Amendments to the Drawings:

## REMARKS

FIG. 2

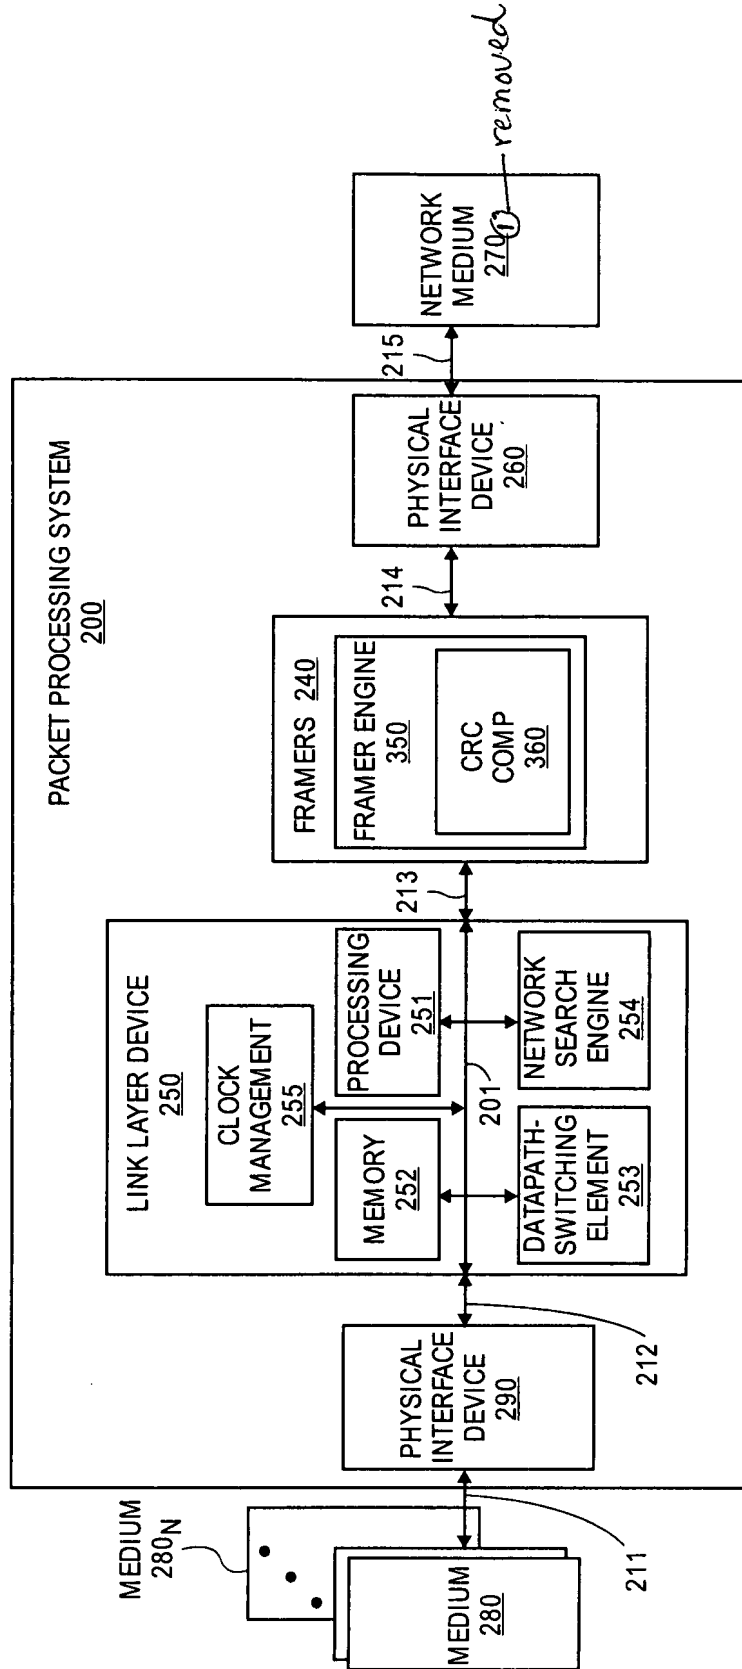
The attached drawing sheet(s) include changes to Figure(s) 1A, 1B, and 2. In Figures 1A and 1B, the “Prior Art” legend has been included. Applicant respectfully submits that the amended Figures 1A and 1B overcome the objection. Figure 2 has also been amended to change the reference label 270<sub>1</sub> to 270. Also, the specification has been amended to change the reference label 260<sub>1</sub> to 260. Accordingly, Applicant respectfully requests that the objections to Figures 1A, 1B, and 2 be withdrawn.
